Answer to Reviewer 1:

Figure 7. Example of two cases where the linear accumulation method was applied within an NSS-NTF chamber to calculate positive (a) and negative (b) CO₂ fluxes with Air Enquirer Kit #03.

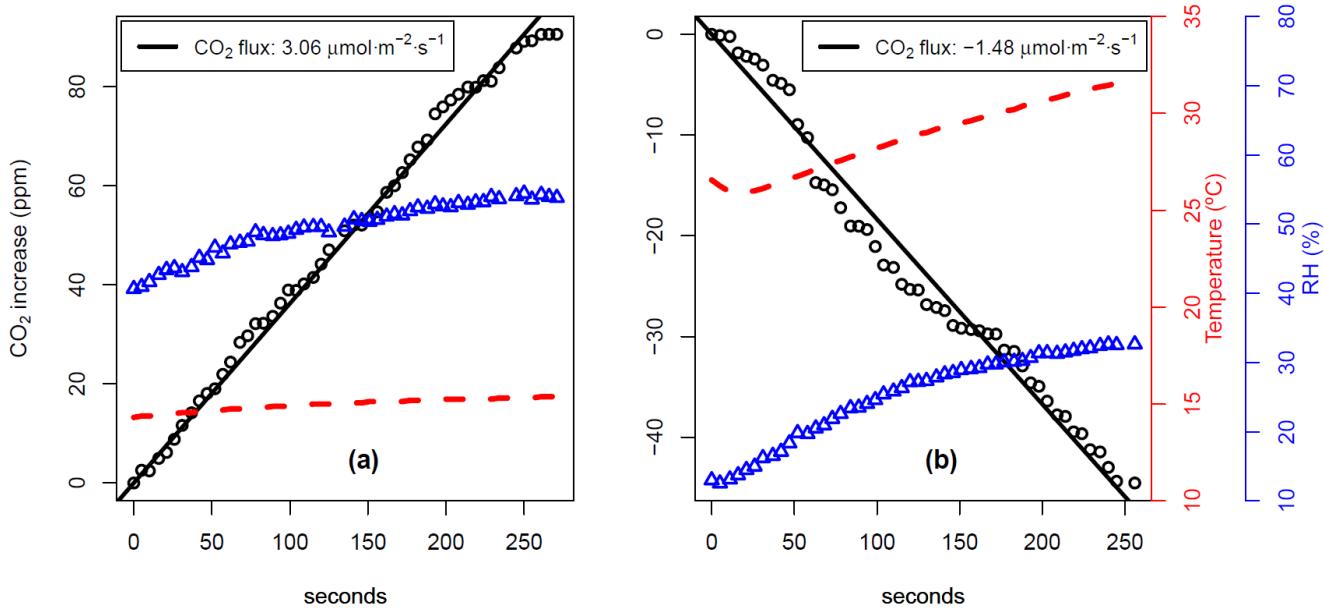
2) L88: *In my experience employing very similar sensors (SenseAir LP8), air humidity has a large effect on the data quality, particularly for RH > 80, causing a highly nonlinear saturation in the measured concentration. Could you please report the RH range used for calibration? As you measure directly above soil, I would expect the RH in the chamber to routinely reach these values. Did you experience this? This could have an impact on data quality, particularly if you experience a sharp increase in RH within the chamber during the measurement time. Could you show the graph of RH for the linear accumulation experiment of Figure 6?*

Answer: As asked by the reviewer we have added both temperature and relative humidity values measured within the NSS-NTF chamber during the measurement examples shown in Figure 6 (in the revised version is Figure 7). In the NSS-NTF there is always an increase in temperature and relative humidity, but this increase is not sharp, probably thanks to the really short period of time of the measurements. In addition, for the reviewer we added here in Figure A1 a plot with the temperature and RH data from the SSTF experiment of Figure 5 (now Figure 6). We did not observe RH > 80% neither for NSS-NTF or for SSTF chambers.

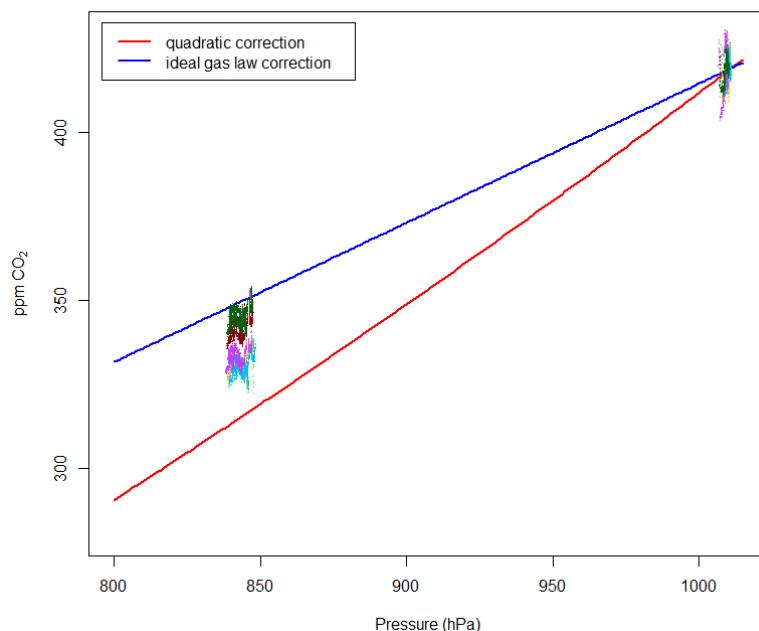
7) L183 you report that pressure has the largest effect of the sensor response and that pressure compensation provides the largest reduction in RMSE. Why did you choose to use a linear model for pressure compensation instead of using the quadratic formula suggested by SenseAir in their application note? (see <http://www.co2meters.com/Documentation/AppNotes/AN149-Senseair-Pressure-Dependence.pdf>)

Answer: First of all, we thank the reviewer to indicate us this link. We did not know about this technical sheet. During our study we found out the following documents (https://cdn.shopify.com/s/files/1/0019/5952/files/AN001_Pressure_Compensating_of_a_CO2_Sensor_Rev_1.0_03_May_2021.pdf) where a linear approximation, considering the Ideal Gas Law, was recommended. However, in order to evaluate the reviewer comment, we have made

Pressure tests for all sensors. The plot copied below reports CO₂ sensors data in relation to the environmental pressure during the experiments (≈ 1010 hPa and ≈ 845 hPa at IC3 and at CRAM sites, respectively). To skip the CO₂ concentration influence we filtered the data using only those ones when the CO₂ concentration measured by the reference instrument was in the interval 415 ppm - 425 ppm. The plot also shows the quadratic (red line) and lineal (blue line) models calculated using the previous cited references for a concentration of 420 ppm. Bias for CO₂ data is corrected for every kit taking as reference the 1010 hPa data. It can be seen that each sensor seems to have a its own Pressure dependency but, generally, data get closer to the linear ideal gas law fit.

On the light of it, what we did was to apply a three steps correction/calibration:

- a. correction for wet air-dry air;
- b. correction for Pressure influence following the ideal gas law;
- c. calibration of the CO₂ sensor response using a multiparametric fit.
